DART AEROSPACE LTD	Work Order:	83181
Description: Crosstube Assembly (412 High Aft)	Part Number:	D412-664-243
Inspection Dwg: D412-664-243 Rev: E		Page 1 of 1

DRAWING NO.	TITLE REV. E	DART AEROSPACE LTD	D.E.O. NO.	SHEET NO. SCALE
D412-664-243	CROSSTUBE ASSEMBLY (412 HI AFT)	ENGINEERING ORDER	D412-664-243-E-1	SHEET 1 OF 2 NTS
DRAWN	CHECKED AND	MFG. APPR.	APPROVED MAP	DE APPR.
DATE 11.03	1.31 DATE 11/03.31	DATE // 03.31	DATE 11/03:31	DATE 11-03.31

DRAWING N		REV. E	DART AEROSPACE LT	D.E.O. NO.	SHEET NO.	SCALE
D412-664	-243 CROSS	TUBE ASS'Y (412 HI AFT)	ENGINEERING ORDER	R D412-664-243-E-2	SHEET 1 OF 1	NTS
DRAWN	P	CHECKED ASS	MFG. APPR.	APPROVED MY	DE APPR.	
DATE	11.09.07	DATE 11.09.19	DATE ((.09.19	DATE 11.09.19	DATE 11. 99.19

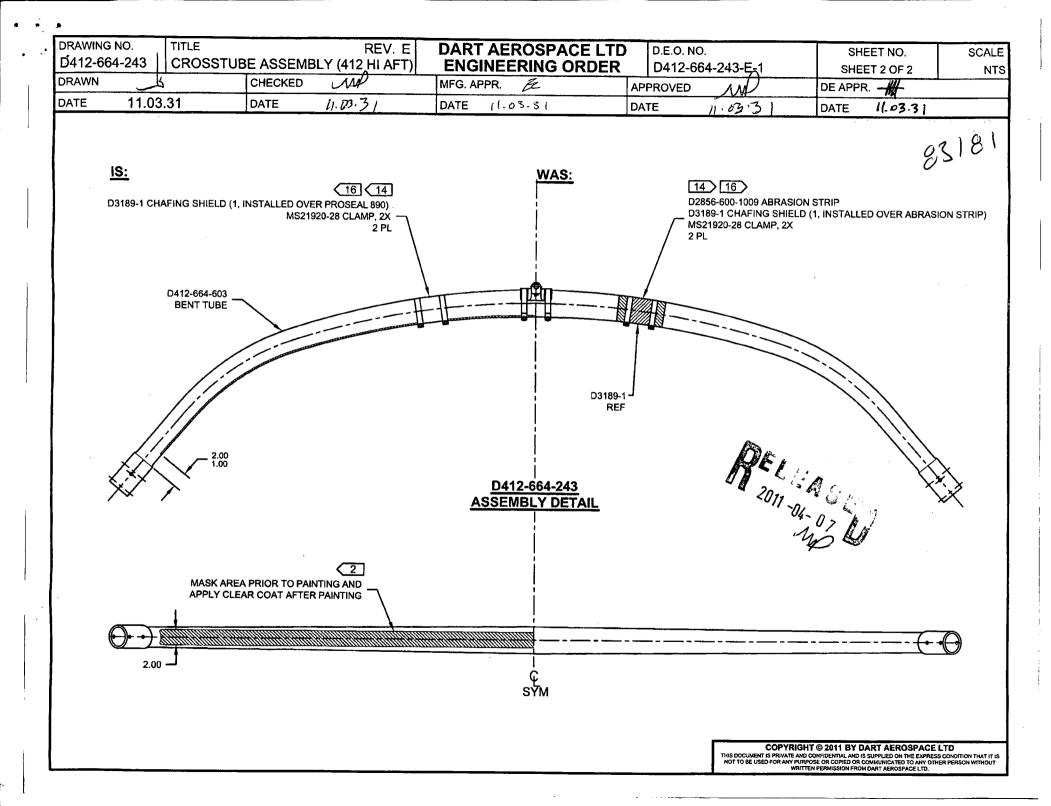
PURPOSE:

REMOVED ABRASION STRIP IN FAVOR OF A THIN LAYER OF PROSEAL 890.

CHANGE:

PARTS LIST IS AMENDED AS FOLLOWS:

NOTES 2 AND 14, SHEET 1 ARE AMENDED AS FOLLOWS:

IS:

Item	Qty -243	Part Number	Description
6	0	D2856-600-1009	ABRASION STRIP

WAS:

T
6	2	D2856-600-1009	ABRASION STRIP

2) FINISH: CHEMICAL CONVERSION COAT PER DART QSI 005 4.1
PRIME INSIDE AND OUTSIDE PER DART QSI 005 4.2
MASK UNDERSIDE OF CROSSTUBE AS SHOWN (HATCHED AREA)
PAINT OUTSIDE PER DART QSI 005 4.2
AFTER PAINTING, APPLY CLEAR COAT ON HATCHED AREA

14) APPLY A THIN COAT OF PROSEAL 890 ON INSIDE CONCAVE SURFACE OF D3189-1 CHAFING SHIELD AND LET CURE PER MANUFACTURER'S INSTRUCTIONS. INSTALL PROSEALED D3189-1 CHAFING SHIELD ONTO CROSSTUBE BY APPLYING A THIN COAT OF PROSEAL 890 ONTO CROSSTUBE. BE SURE TO ELIMINATE ANY AIR GAPS.

WAS:

- 2) FINISH: CHEMICAL CONVERSION COAT PER DART QSI 005 4.1 PRIME INSIDE AND OUTSIDE PER DART QSI 005 4.2 PAINT OUTSIDE PER DART QSI 005 4.2
- 14) INSTALL D2856-600-1009 ABRASION STRIPS WITH A 0.13 REF GAP ON BOTTOM SIDE OF CROSSTUBE PER QSI 035.
